**BYLONG COAL PROJECT (SSD 14\_6367)  
MINOR REFINEMENTS TO PROJECT DESCRIPTION**

BYLONG COAL PROJECT

**FIGURE 2**

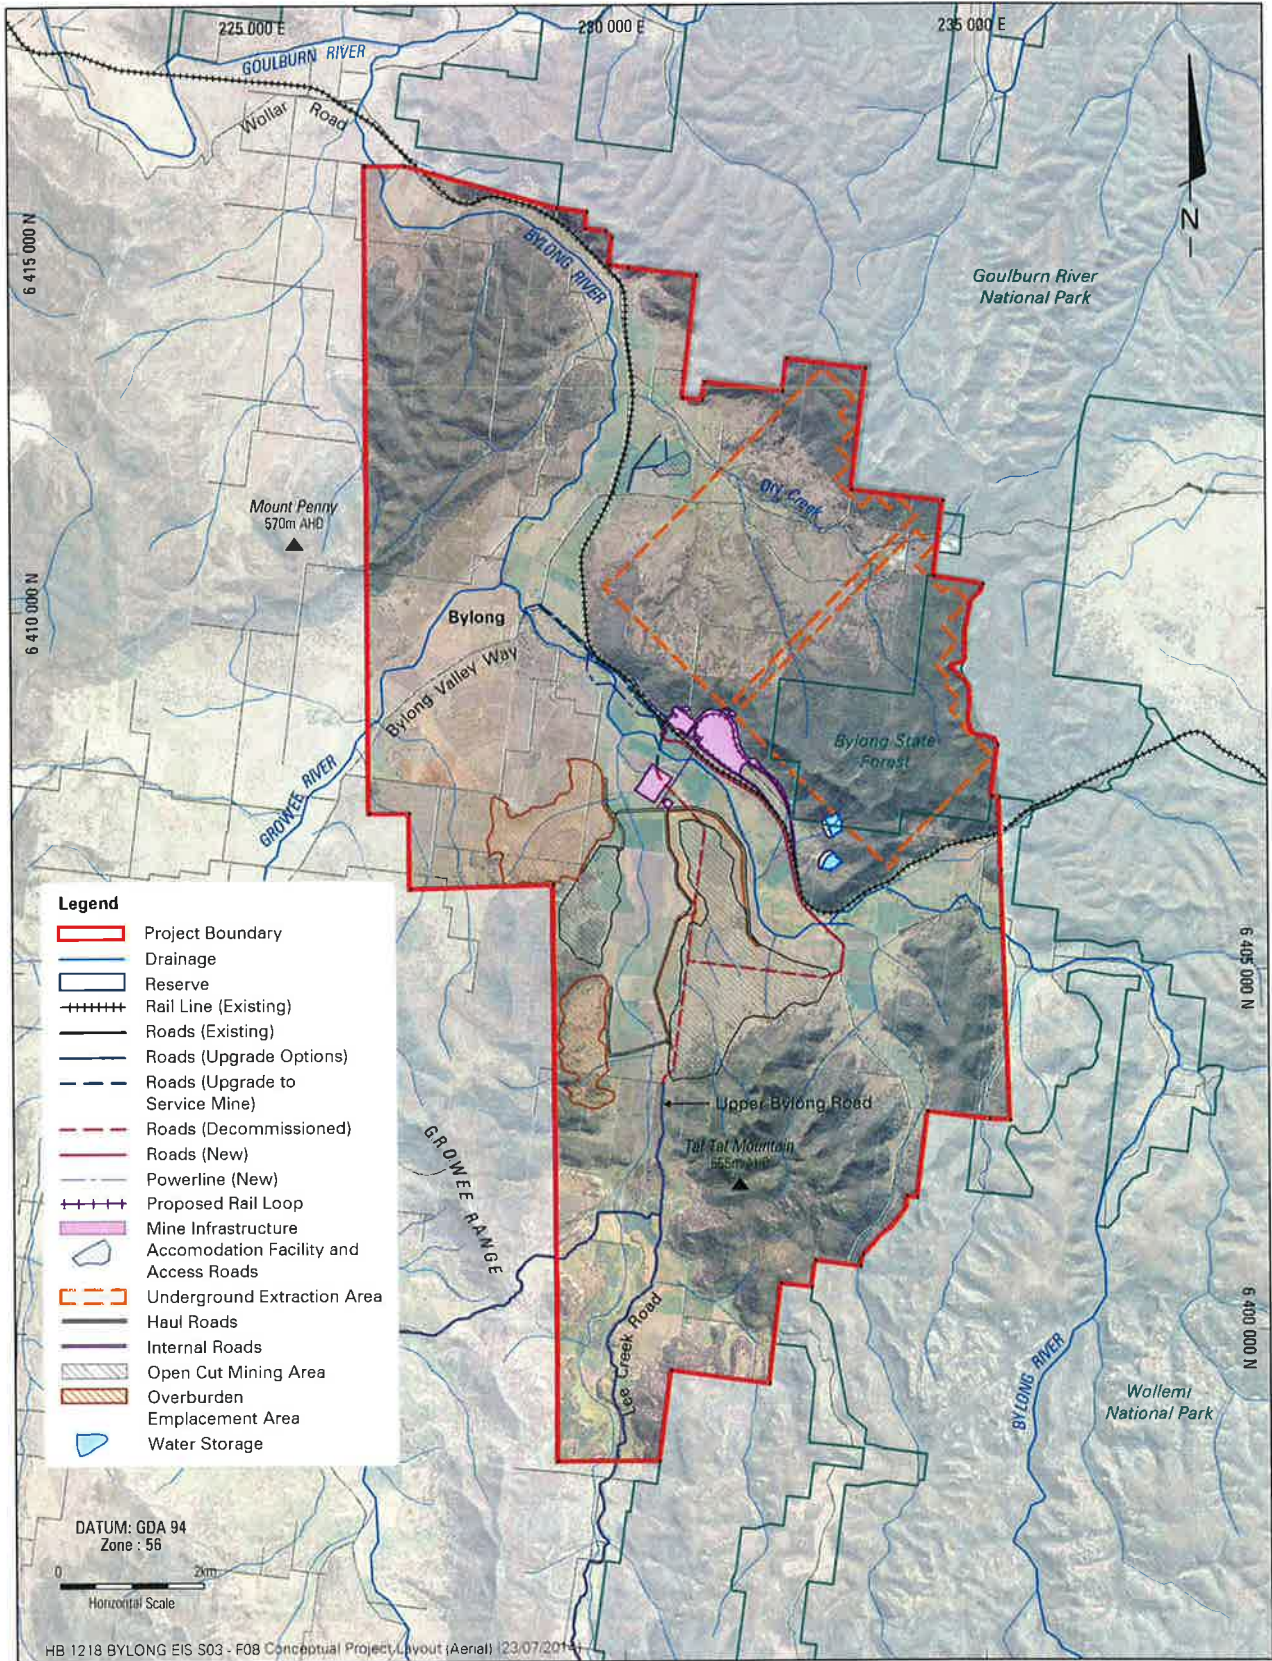
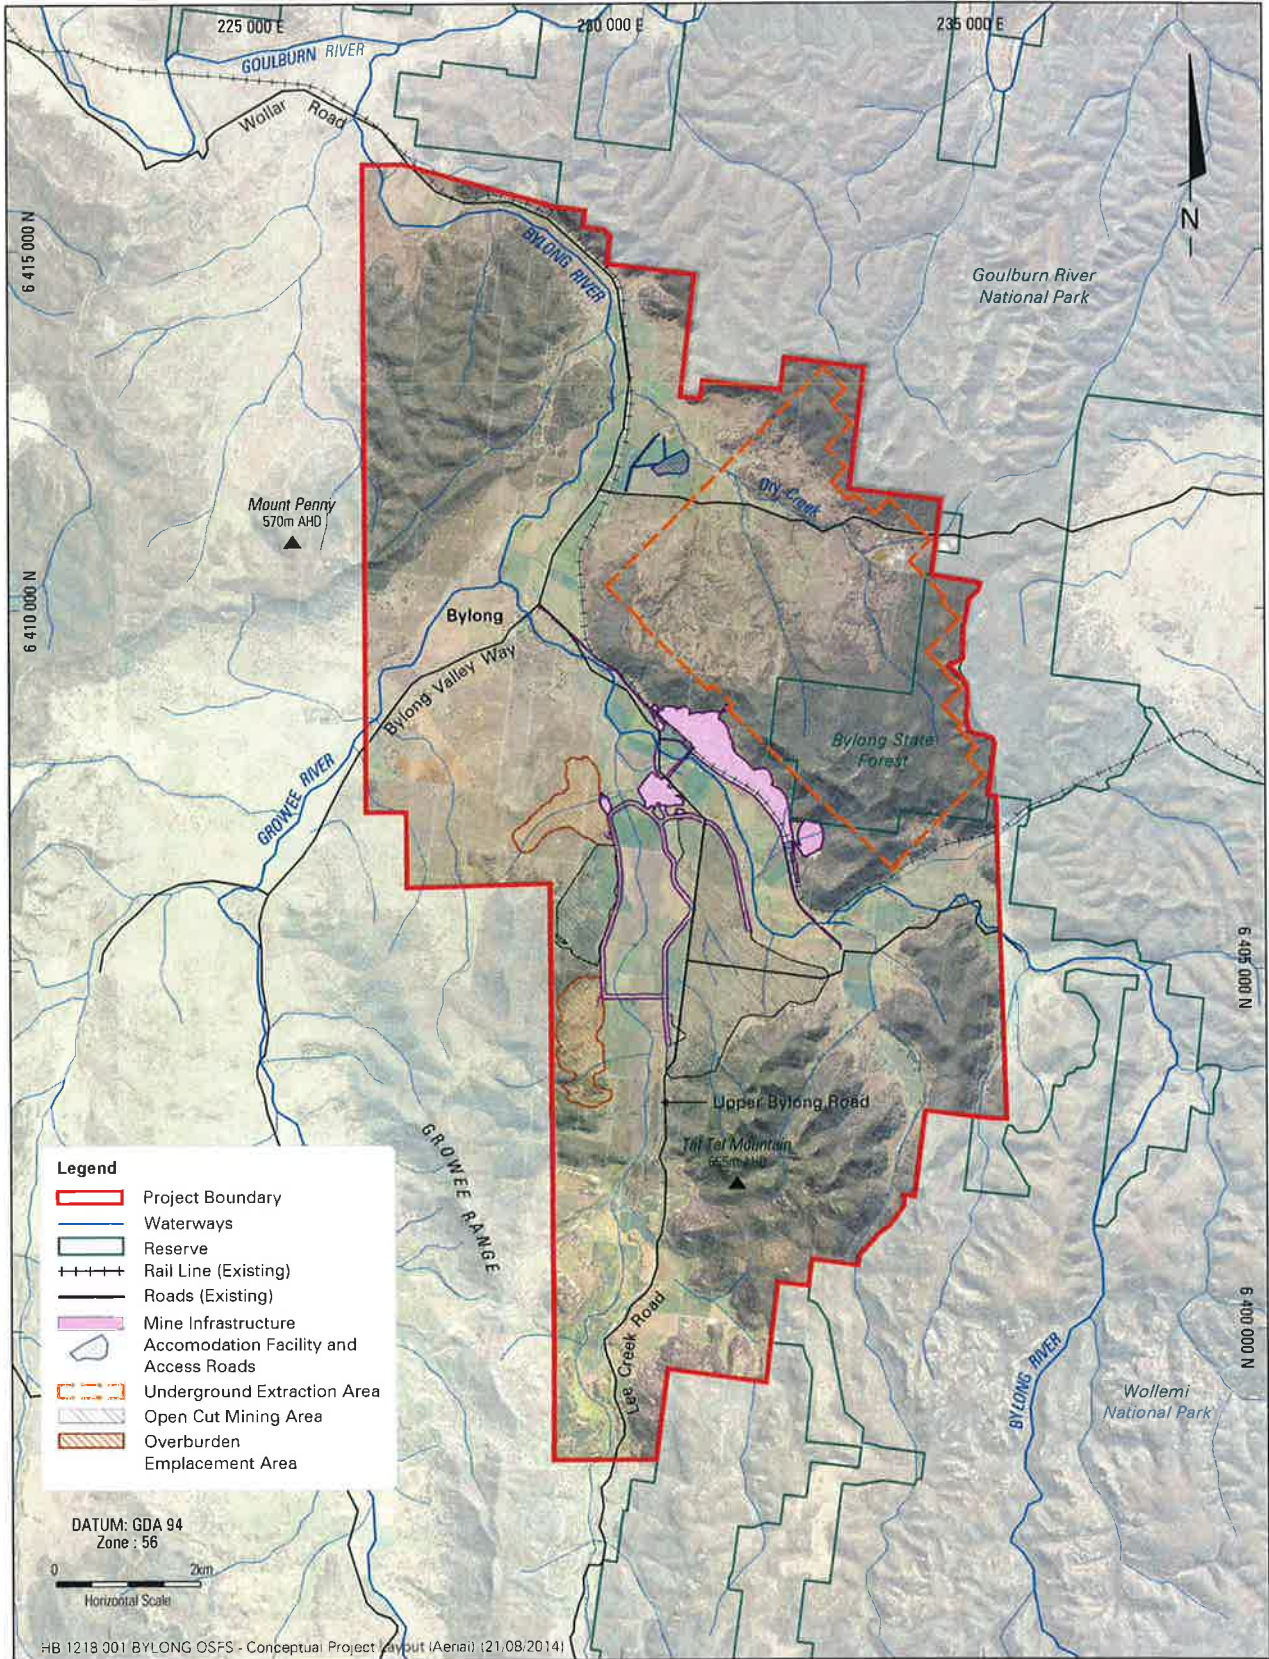
Coal exploration activities have enabled the gathering of additional information to improve the knowledge of the available coal resource within the Authorisations. This improved knowledge of the coal resource has encouraged the mine plan and associated scheduling to be refined in an attempt to improve the overall efficiency of the mining operations. Both the open cut and underground mining methods have been refined during the mine planning process since the preparation of preliminary documentation. **Figure 1** illustrates the Project Layout as presented within the Background Document. **Figure 2** illustrates the refined Project Layout that will now be assessed within the EIS.

The area within the underground mining footprint that was proposed to be left unmined in the mine plan presented in the preliminary documentation will now be mined as part of the adjusted underground extraction area. There are also some other minor adjustments to the extents of the Extraction Underground Area (see **Figure 2**).

The initial rail loop design presented within the Background Document has been determined to be very costly as a result of considerable cut and fill activities required for this design. It also presented challenges to the construction program for the Project. Further engineering work has been completed to design the rail loop with a reduced footprint, whilst also minimising construction time and cost. The CHPP which will be developed within the rail loop has also been re-engineered to reflect the reduced footprint of the rail loop. The revised footprint for these pieces of infrastructure is illustrated in **Figure 2**.

The Open Cut and Underground Mine Infrastructure Areas (MIAs) were also refined with the engineering work, resulting in some minor changes to the Project Disturbance Boundary. In light of the various changes to the mine plan and associated infrastructure, the latest engineering work has led to the revised design and siting of sediment dams surrounding the open cut mining areas and infrastructure areas, along with a Mine Water Dam and CHPP dam design now positioned in more optimal locations.
